## **APPENDIX A**

### **DETAILED RESPONSES TO COMMENTS**

**MDNR COMMENTS AND RESPONSES ON THE  
FEASIBILITY STUDY/PROPOSED PLAN FOR THE ST. LOUIS DOWNTOWN SITE  
ST. LOUIS, MISSOURI (April 1998)**

Figure 4 - Northbound at MP 38.8 - crest vertical & small radius horizontal curve combination

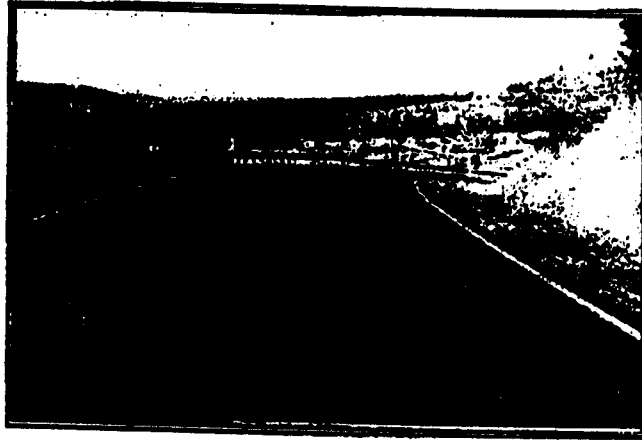
The minimum lane width and minimum total roadway width for a 900 foot radius horizontal curve per the Modified Design Level is 11 feet and 26 feet, respectively. However, wider minimum lane widths and total pavement widths are required as the horizontal curve radius becomes less than 900 feet. For instance, a 500 foot radius horizontal curve requires a minimum 12 foot lane width and 28 foot total pavement width.

Before the current DMC proposal were to be implemented, I highly recommend that the exact radius of each suspect curve be determined and the curve widened to at least the minimum widths outlined in the Modified Design Level. Action should be taken to mitigate the large increase in likelihood of head on and run off the road collisions in these curve areas. Further shoulder widening should be considered beyond these minimums in areas where pedestrians are likely to be walking and no refuge area exists for their safety.
